Service Sink Faucet S-2490, S-2490-CHKS

Project Name: Webster University-**ISB**

Copies	No.	Description
1 PDF	224216P02	(Submittal No.'s)
		(Cannon #22 4216.16-001) - (Paric #15051-) - (WES #607)
		➤ Commercial Sinks
		• Clinical Service Sink CSS-1
		• Scrub Sink SS-1
		• Sink SK-1
		• Garbage Disposer GD-1
		• Sink SK-2
		• Sink SK-3
		• Mop Sink MS-1
		• Kitchen Sinks KS-1, KS-2, KS-3

SPEC SECTION: 22 4216.16
Commercial Sinks

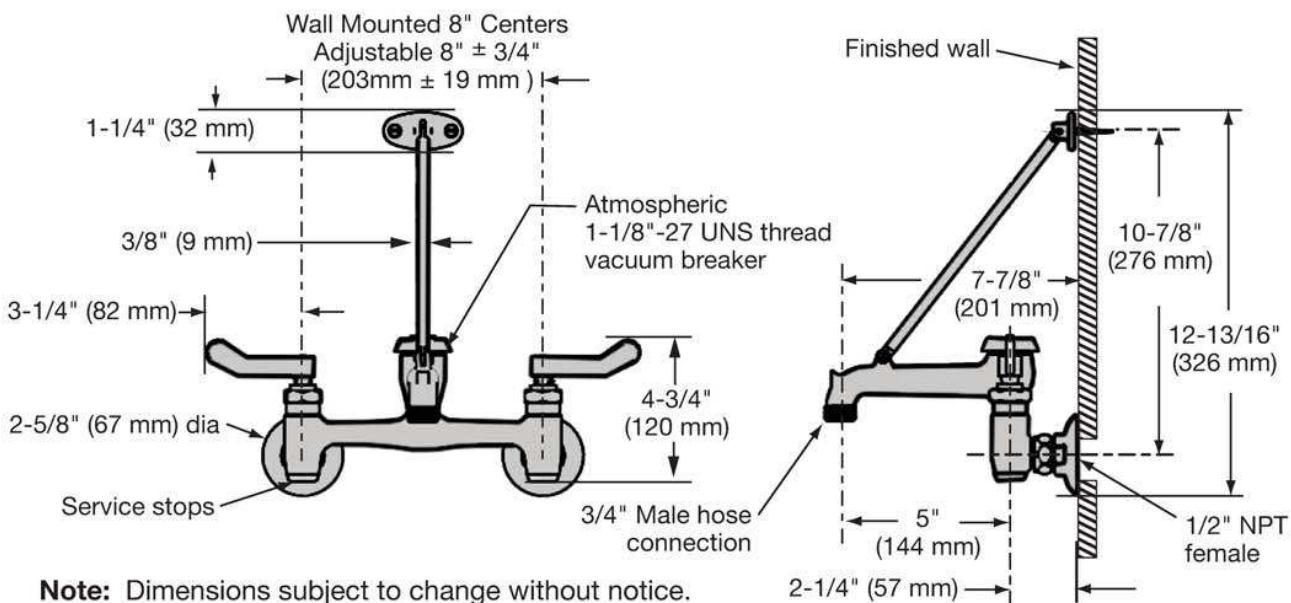
X					Supply Risers BrassCraft Model 1-12AC	
	X				Escutcheons Proflo Model PFE7	Escutcheons are specified to be cast brass. Refer to specification section 220518.
Sink SK-3						
					Fixture	Sink is integral with the countertop. Coordinate with architectural drawings.
X					Faucet Chicago Faucet Model 786-GN2BVBE3-2ABCP	Provide under counter waste and supply protective piping covers as required. Verify requirements with the architectural drawings.
X					Drain Assembly Elkay Model LK35	
X					P-Trap Proflo Model PFPTB403	
X					Angle Stops BrassCraft Model SCR19XC	
X					Supply Risers BrassCraft Model 1-12AC	
	X				Escutcheons Proflo Model PFE7	Escutcheons are specified to be cast brass. Refer to specification section 220518.
Mop Sink MS-1						
X					Fixture Fiat Model TSB-3000	
X					Faucet Symmons Model S-2490	
X					Hose Bracket Proflo Model PF296	
X					Hose Proflo Model PFSSHE	
X					Mop Bracket Proflo Model PF245

X					Wall guards Proflo Model PFWG24S	
Kitchen Sink KS-1						
	X				Fixture Elkay Model ECTSR25229BG	Cut sheet indicates 3-hole punch – verify this with faucet 4-hole punch requirement
X					Faucet Chicago Faucet Model 1102-202358AB
